PARTS BULLETIN

Models: **135-230 kW John-Deere Powered**

Subject: **Alternator and Engine Wiring Harness Change on 6081 Engines**

Figure 1 Alternator Option Code 3106 Replacement Parts

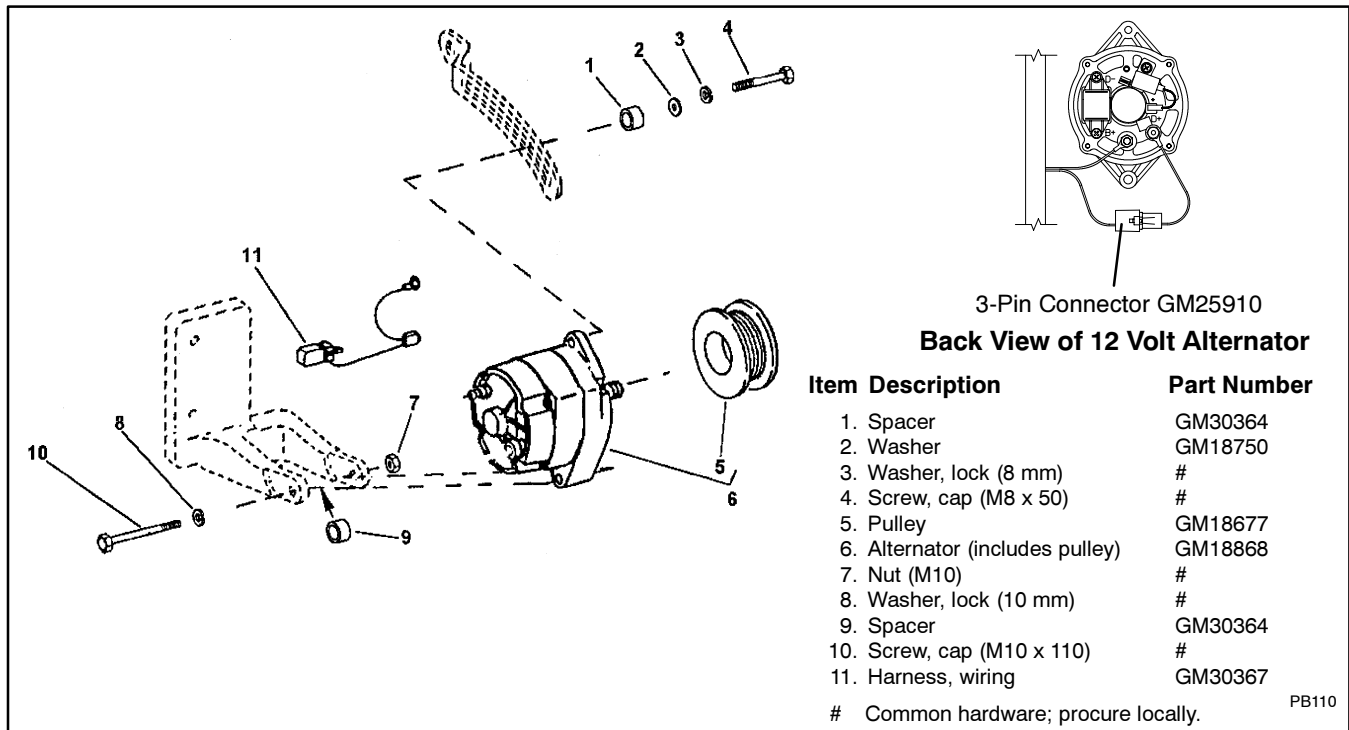
John Deere Power Systems changed the battery charging alternator on 6081 engines. The engine alternator option codes changed and engine wiring harnesses were modified as a result of the change.

Engine harnesses were modified to include 3-pin connector GM25910. The connector will not fit on alternators equipped with alternator option codes 3140 and 3142. When replacing the engine wiring harness on

When replacing the alternator on subject models, use the engine option code label affixed to the side of the engine block and the table below to determine the alternator replacement part numbers.

a generator set equipped with alternator option code 3140 or 3142, remove the 3-pin connector from the new harness and reconnect the lead to the alternator wiring harness using customer-supplied terminals.
